**KANEPACKAGE PHILIPPINE INC.**

INVESTIGATION REPORT FORM (IRF)

Customer	EPSON PRECISION PHILS. INC.- ASP/EPLB	Attention To	REXEL ALMARIO
Item Code	513238500	Department	PRODUCTION
Item Description	OUTER CARTON BOX	Date of Detection	250410
Job Order Number	JO25-M-01152-34	Section Detected	QA SCREENING 5

ILLUSTRATION OF THE PROBLEM

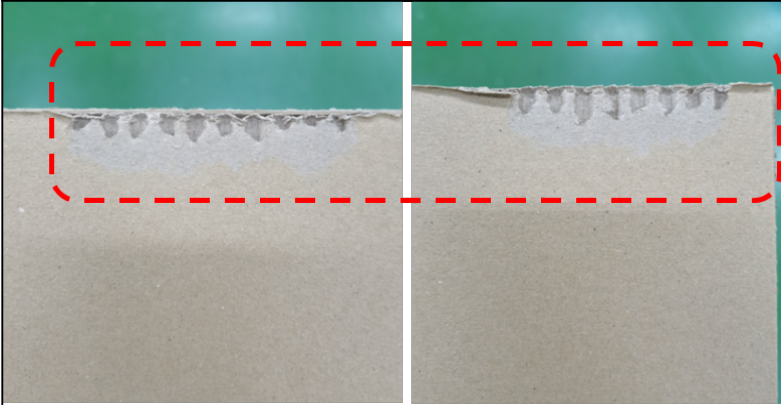
PEEL OFF

ACTUAL: Peel off up to 70mm length**REQUIREMENT:** Maximum of 25mm is still **Acceptable**

WHY 1 : The liner surface of the board was hit on the feed gate of Eqos during running.

WHY 2 : Presence of excess liner and delamination in the edge of the boards.

WHY 1: Assign Packageworld as main supplier of materials for this item. This based on checking and trial run conducted using materials from Sunpack and Packageworld.
